**ROCKER ARM COVER GASKET / ELECTRA GLIDE, SPORTSTER**

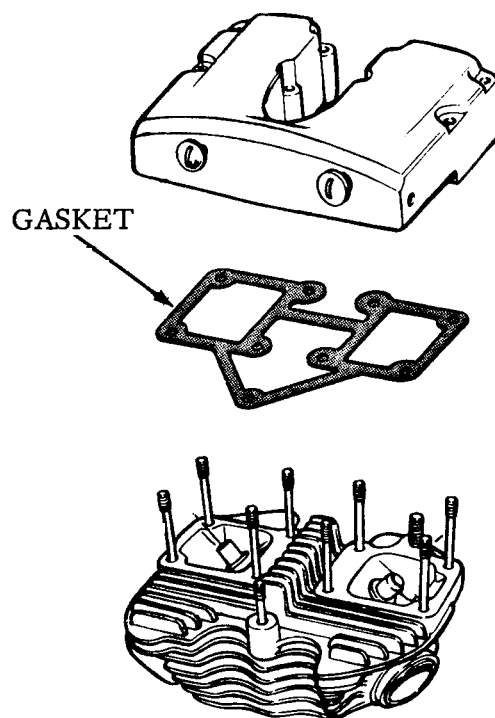
Rocker arm cover gaskets are being used on late 1969 Electra Glide engines beginning May 8, 1969 with engine Serial No. 69FLH 13633. This gasket, part No. 17540-69, can also be used on 74 OHV engines back to 1966.

The Sportster will also have rocker arm cover gaskets, part No. 17536-70, starting with the 1970 model season. This gasket can also be used on Sportster engines back to 1958.

The use of these gaskets will prevent possible oil leakage caused by slight surface irregularities.
